Technical Note – Response to Bicester Delivery Team

Project: Great Wolf Lodge, Chesterton

Date: 7th February 2020

Drawing 1803047-03

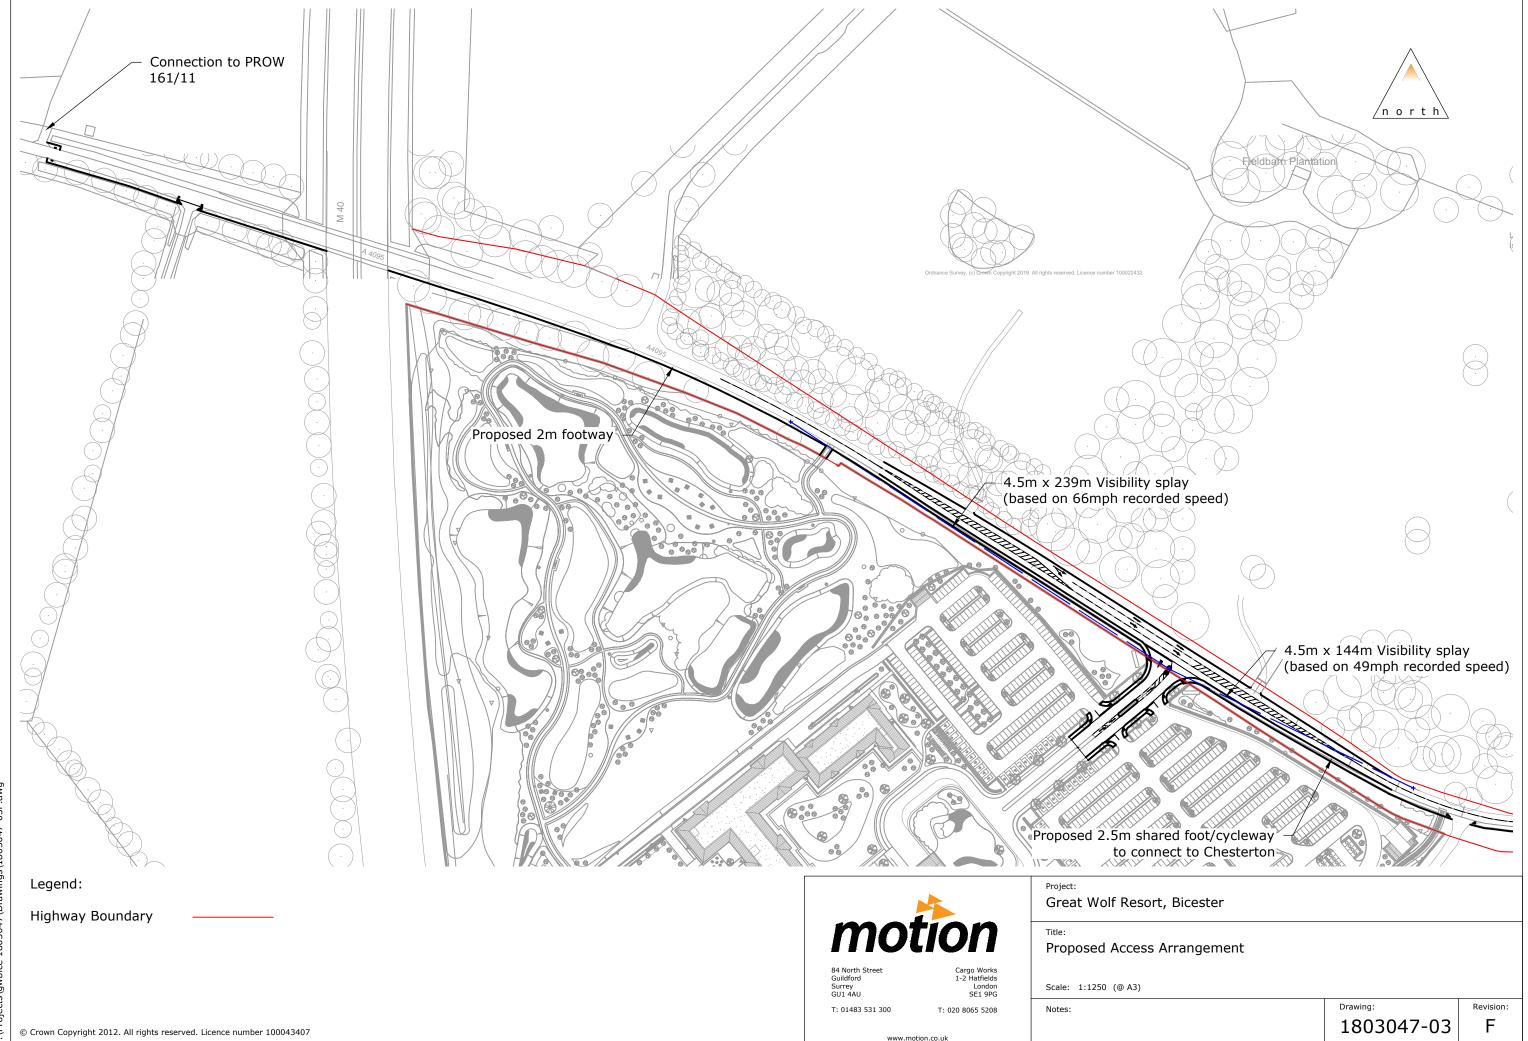
- 1.3 Following submission of the planning application comments have been provided by the Bicester Delivery Team (BDT) at CDC in respect of the submitted planning application. This Technical Note has been prepared in response to the comments from the BDT and provides further details in relation to walking and cycling connectivity, shuttle bus provision and car parking provision.

- 2.1 Following further discussions with OCC, the proposed footway west of the site access is to be extended west to connect with Public Right of Way (PRoW) 161/11 to the west of the M40 overbridge. This provides a betterment to the existing connection between PRoW 161/06 and PRoW 161/11 providing pedestrians with a footway, where they are currently required to walk within the grass verge to connect between PRoW 161/06 and PRoW 161/11. The proposed extended footway is shown on Drawing 1803047-03, attached at Appendix A.
